## Pavilion Park Plaza Comment Survey Results Data Visualizations

## Design features you like

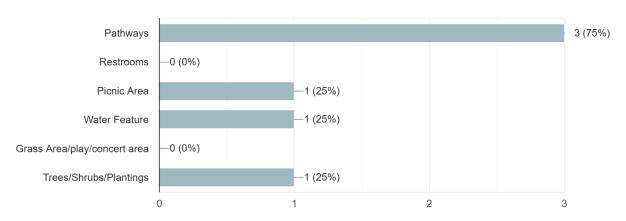
10 responses
